Subject: [FIXED] Beam pipe valves?
Posted by StefanoSpataro on Tue, 05 Mar 2013 11:09:49 GMT
View Forum Message <> Reply to Message

1) viewer.gif, downloaded 805 times

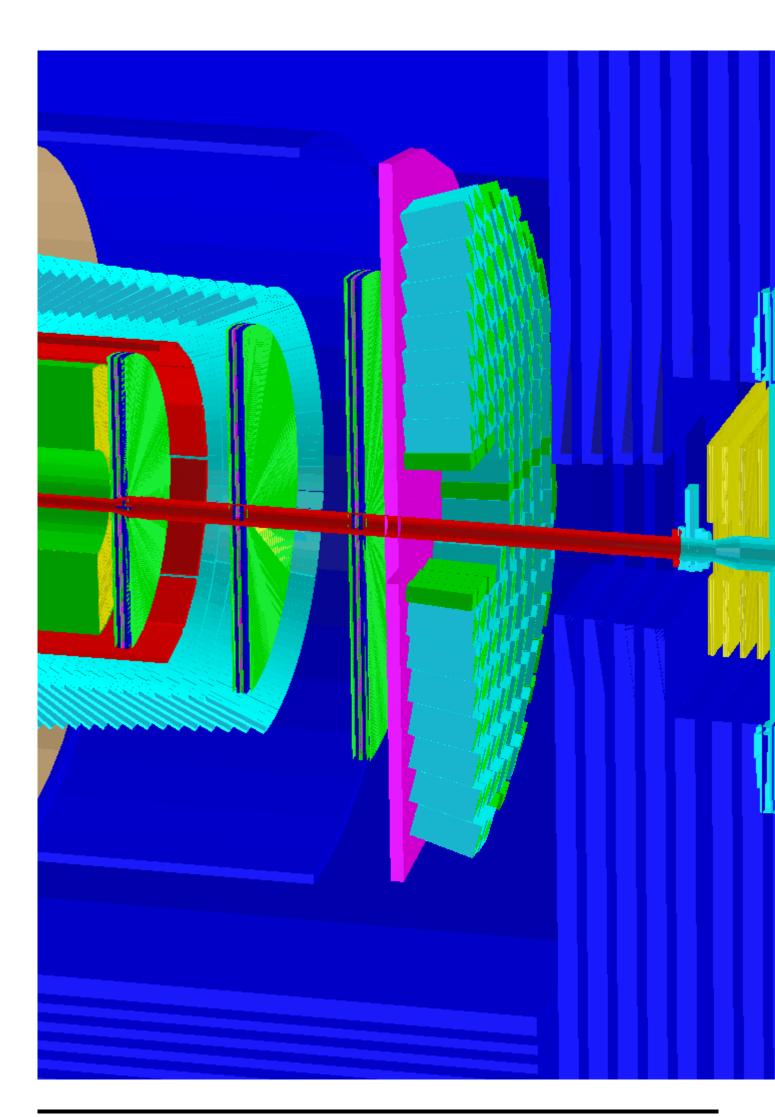
today I plotted the PANDA geometry and I have seen something strange:

In the OGL drawing you can see that the pipe has a sort of "tower" which is in the middle of the muon filter. I am wondering what is wrong there, if the "tower" should be really there, if maybe the muon filter should me modified to host it, or if maybe we have some geometry problems.

Indeed, this is the first pumping station downstream of the target. The description corresponds to what is to be found on EDMS since several years. So I guess that muon description is not up to date?

Fixed!

Please update your mdt folder, in particular those running analysis on forward tracker.
